December 14, 2023 – 6:00 pm Village Hall 235 Hickory Street, Pewaukee, WI 53072

STAFF REPORT

Village of Pewaukee Plan Commission Engineer's Report for December 14, 2023

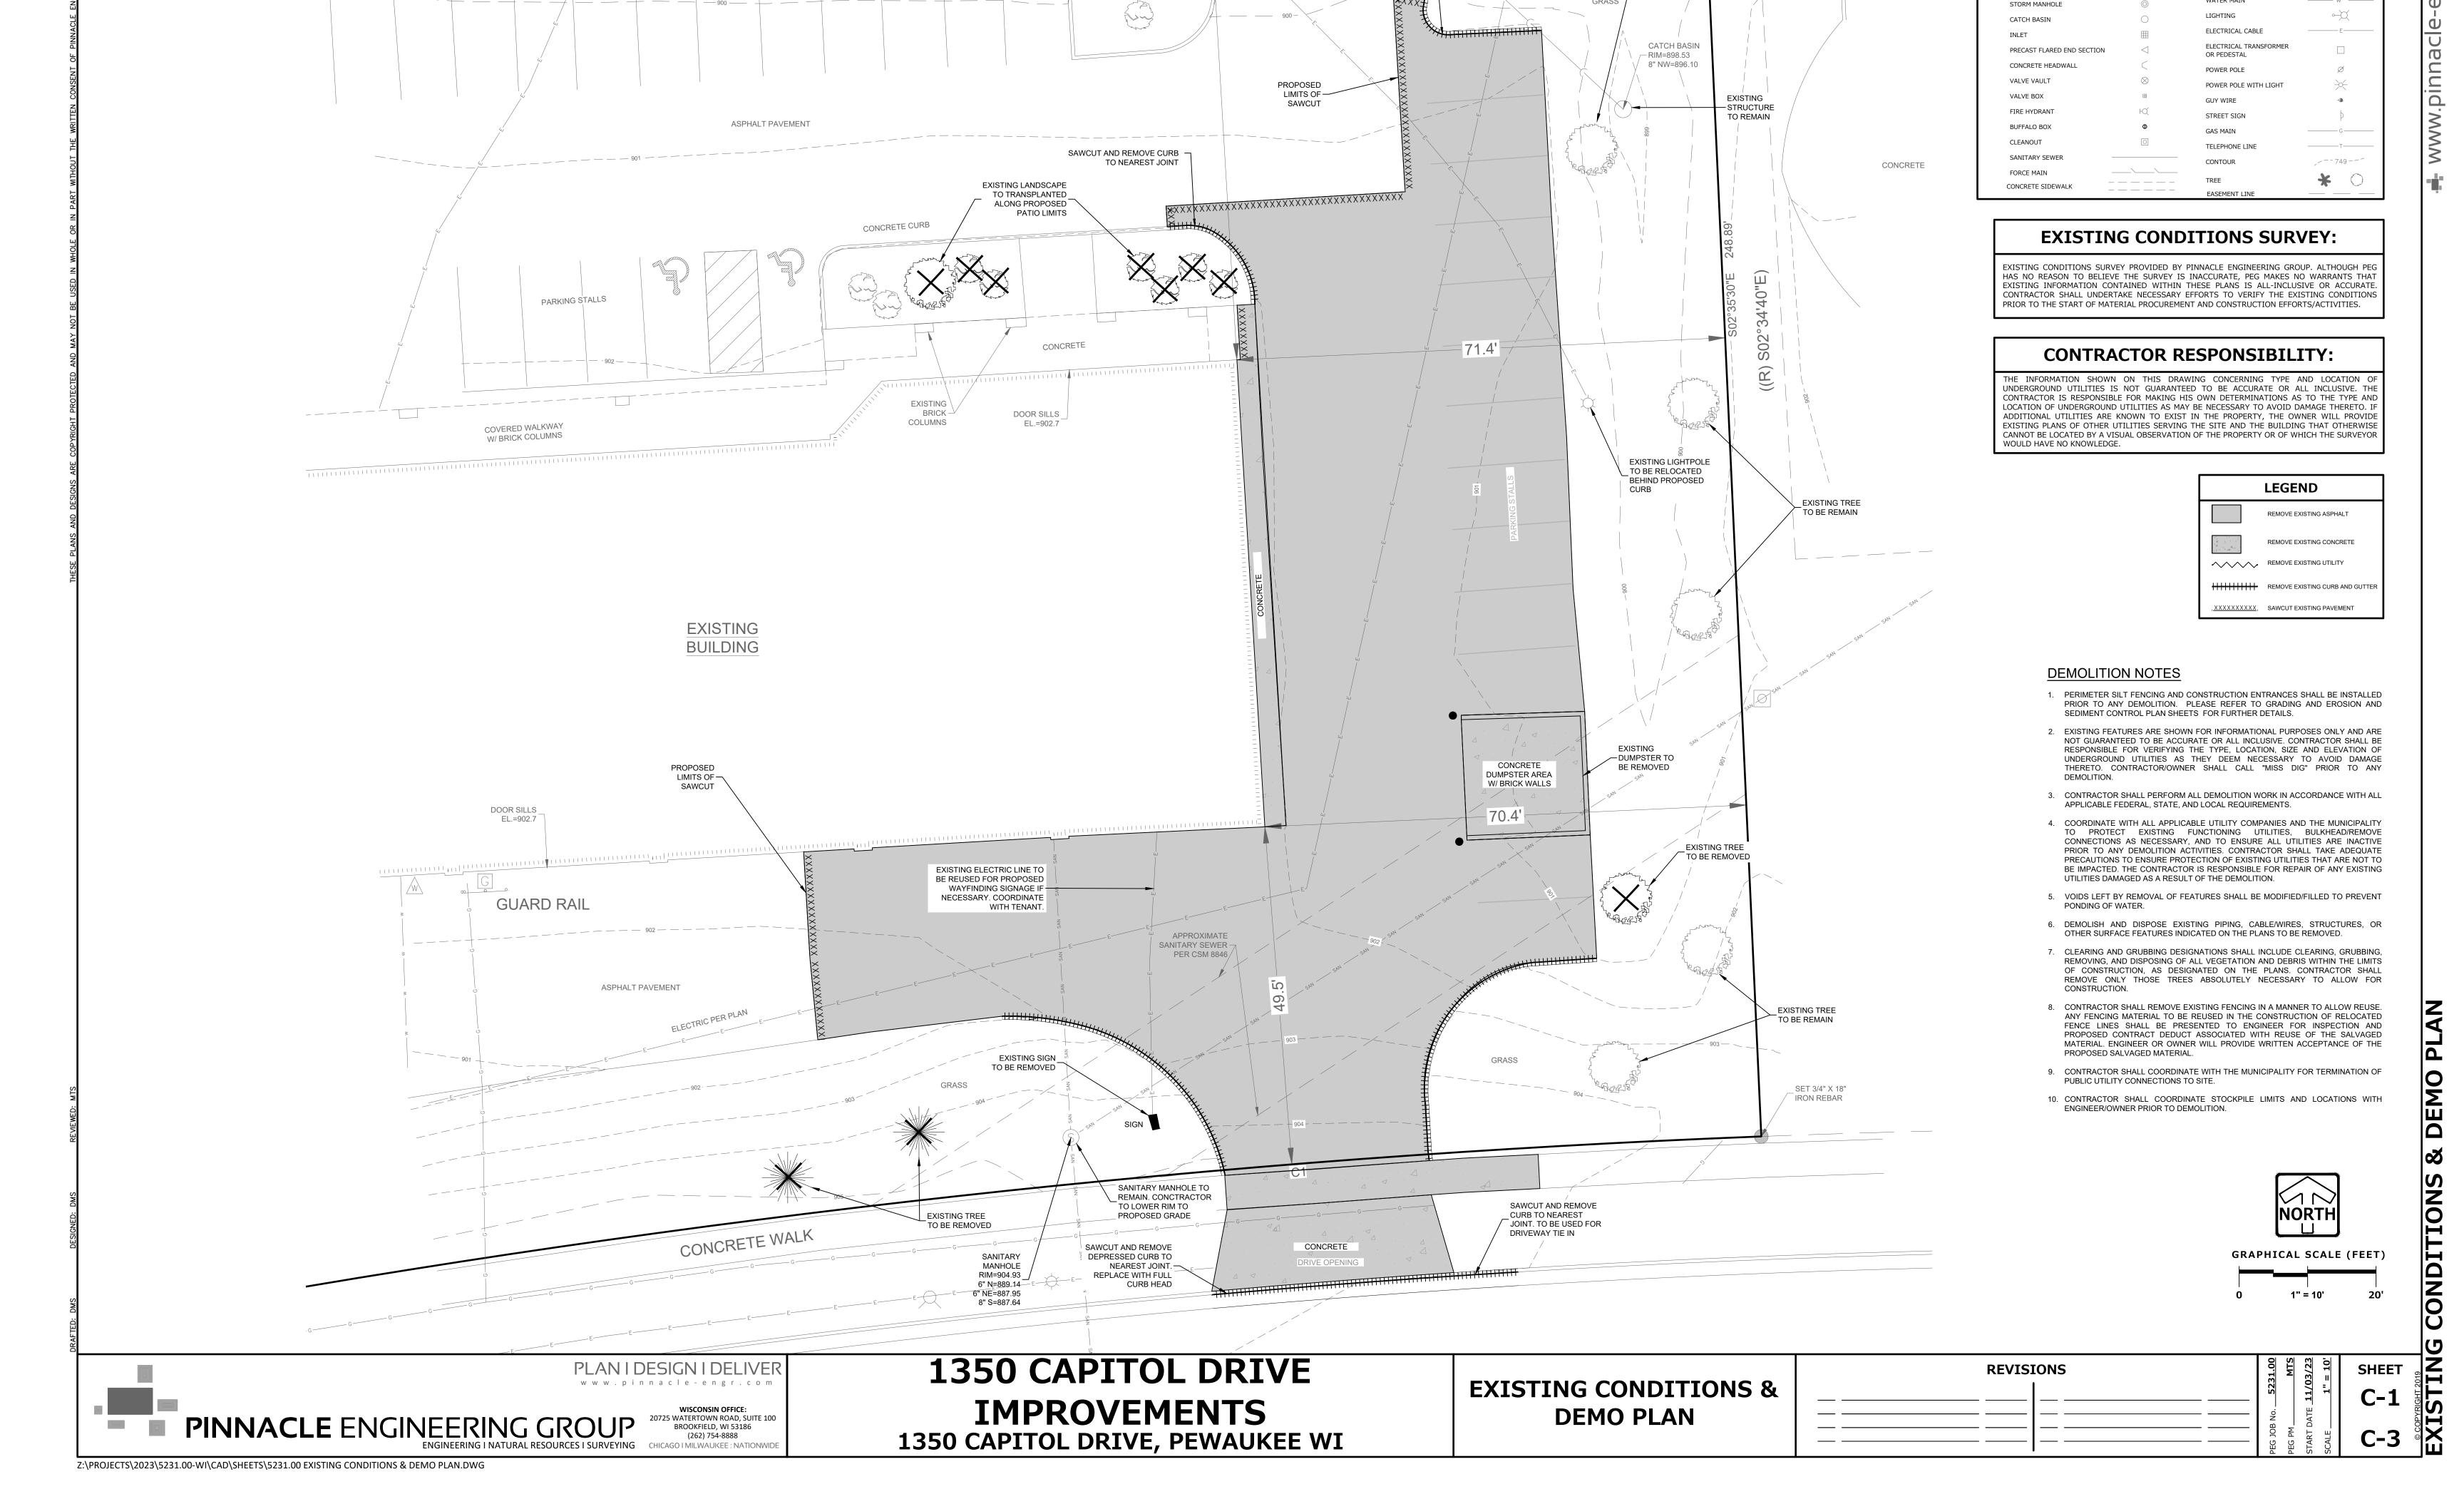
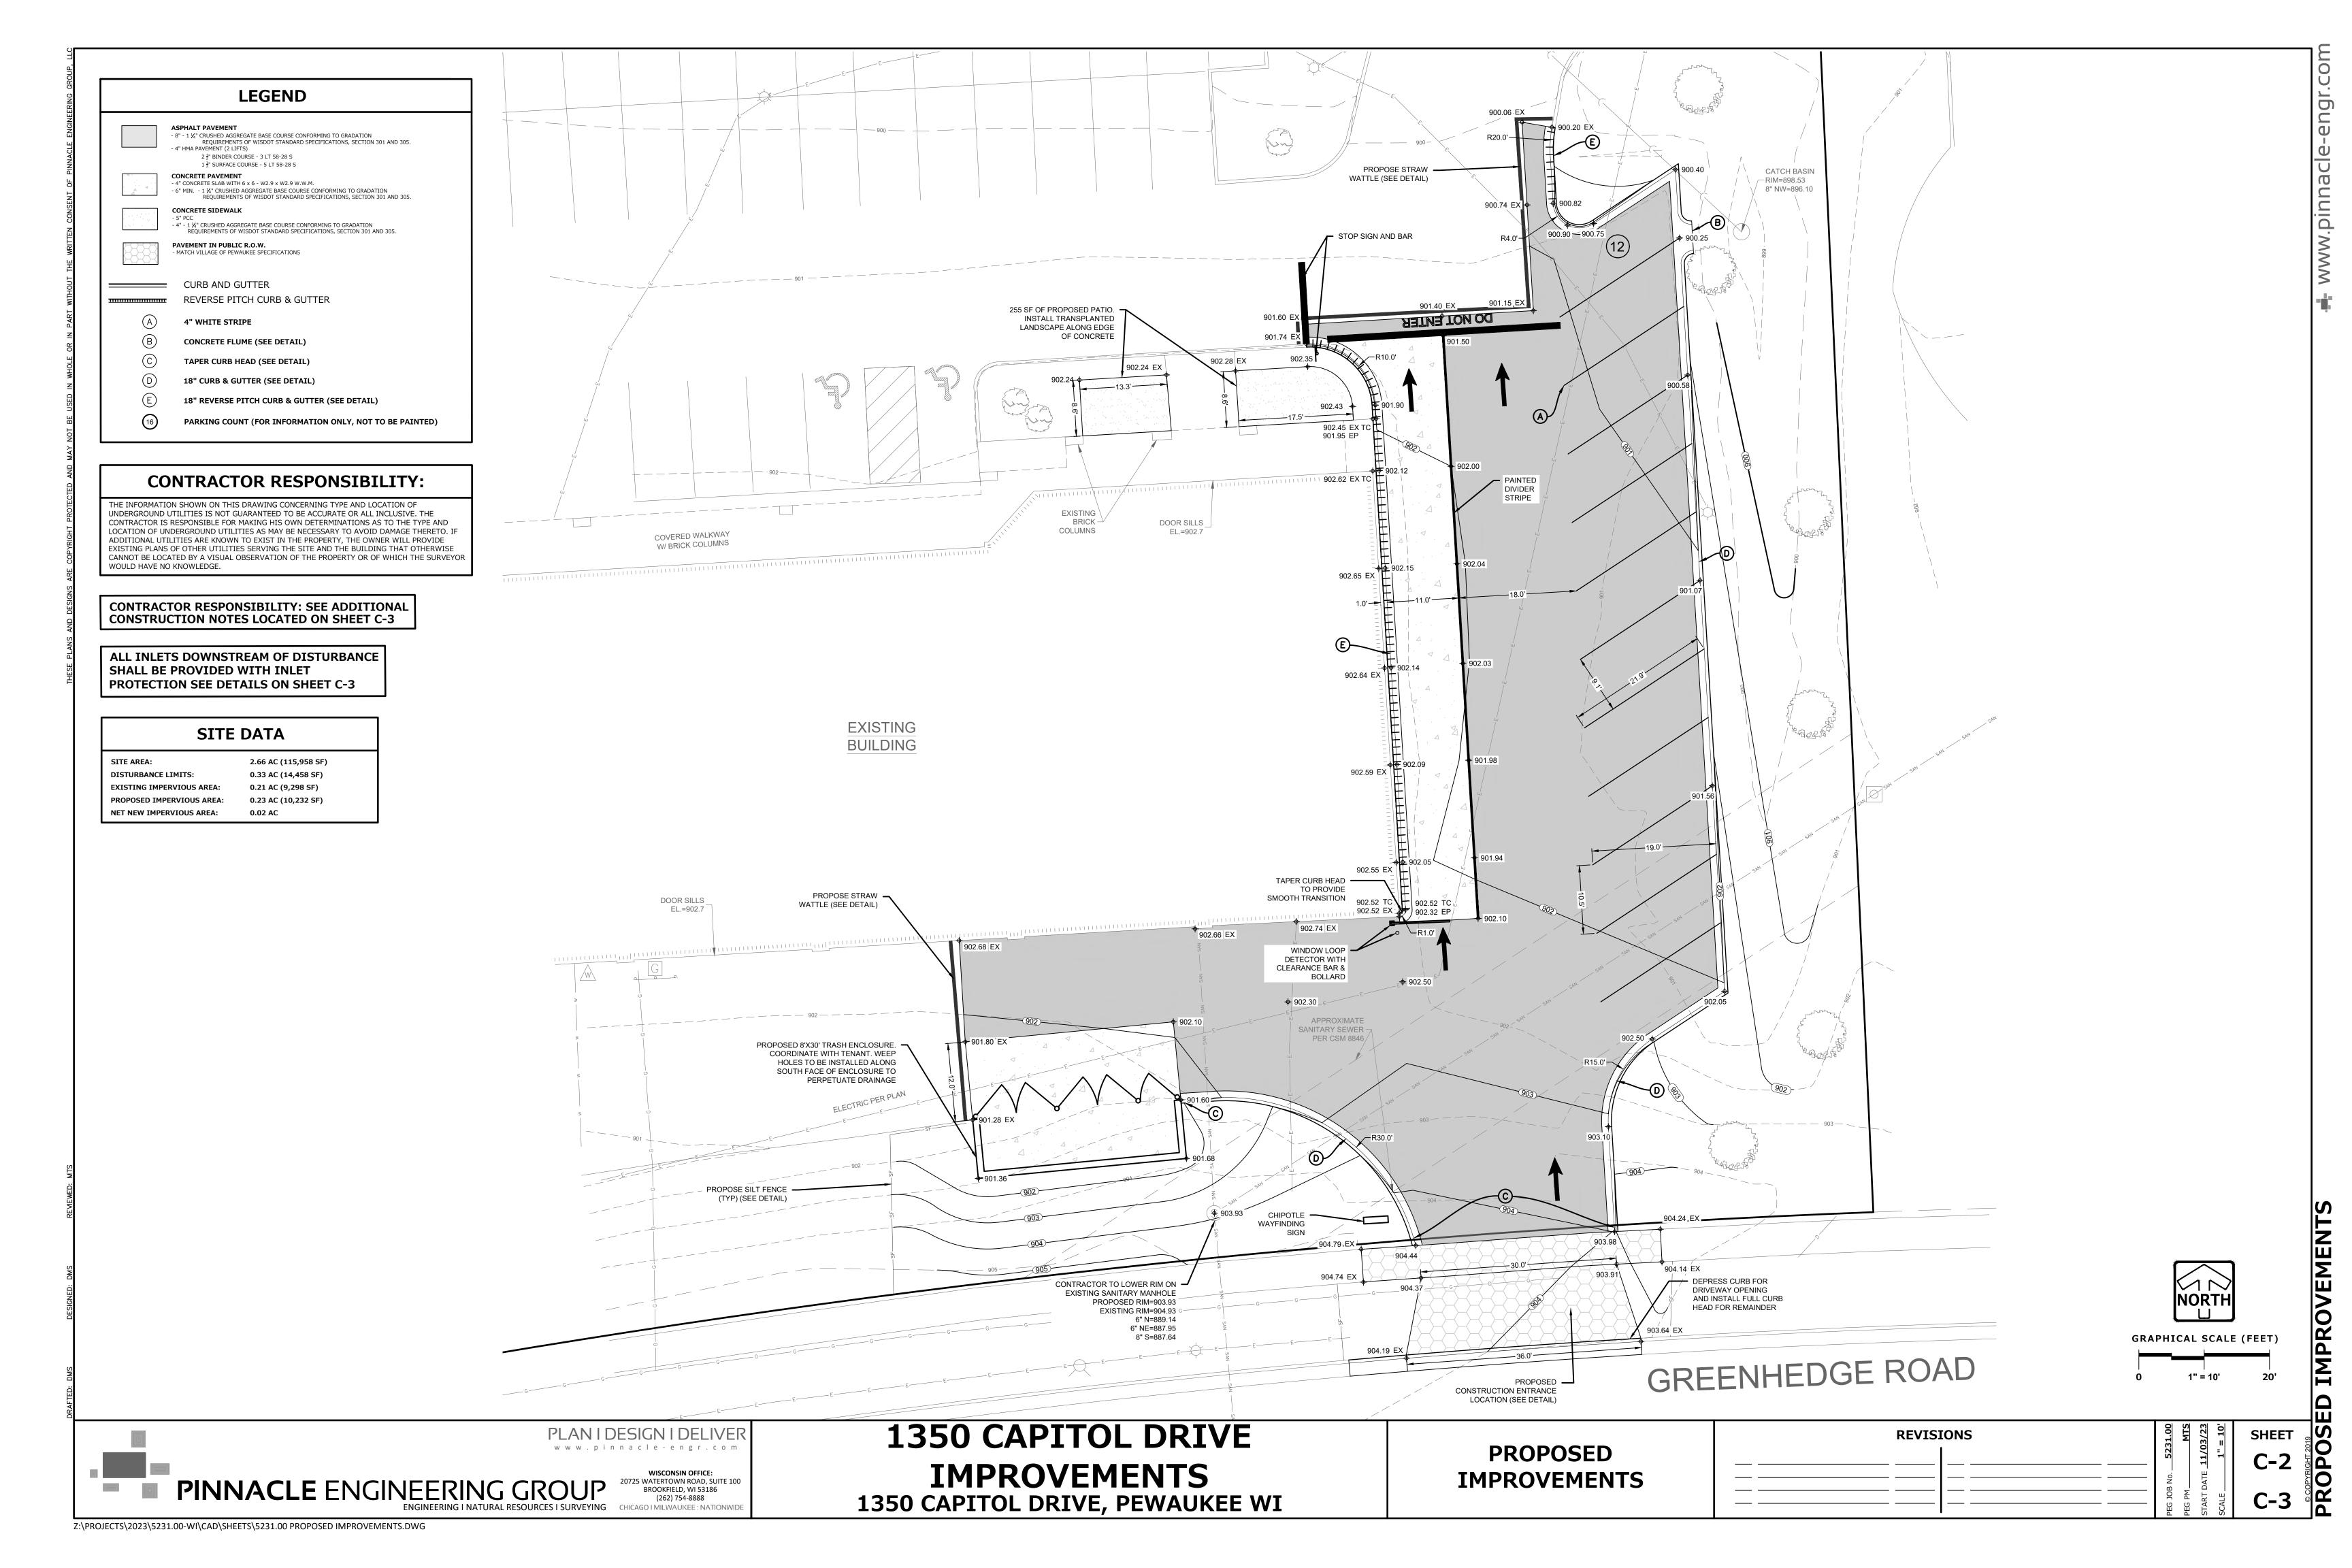
For the area east of building at 1350 Capitol Drive, water sheet flows off the east side of the parking lot into a swale that flows to the north and empties into a storm sewer. The proposed drainage patter is similar; however, the water will sheet flow to a curb and gutter along the east side of the new parking area and flow north in the gutter to a flume that will direct the water into the existing storm sewer system. The curb and gutter will extend the parking lot approximately 2 feet to the east. Pavement improvements near the proposed garbage enclosure will not change the existing drainage pattern.

Since southbound traffic will not be able to access Greenhedge Road on the east side of the 1350 Capitol Dr. building, traffic exiting the site will have to go west to the west side of the building and then south to exit onto Greenhedge Road. The site also has other exit options such as Meadowcreek Drive and Willow Grove Drive through adjacent properties. With the change in the traffic pattern, additional signage and line marking will be necessary as shown on the plans. There are a few other markings that I am recommending below.

I recommend approval of the parking lot and site modifications shown in drawings C-1 through C-3 prepared by Pinnacle Engineering Group dated 11/03/23, subject to the applicant addressing the following items prior to issuance of a permit:

- 4) Applicant to present, for Village Staff review and approval prior to project completion, a suitable landscaping plan, if one is determined by Village Staff to be needed, to screen the relocated dumpster from the surrounding view. Applicant shall complete the installation of any required landscaping plantings within 12 months of project completion;

- 5) Applicant to present a detailed plan for replacing the removed landscaping around the outdoor seating area. This plan shall be subject to review and approval by Village Staff prior to completion of the project and must be installed by the applicant within 12 months of project completion;

- 6) Applicant to replace the tree being removed along the east edge of the parking area (near the existing dumpster location) with a like kind and similar sized tree, prior to completion of the project;
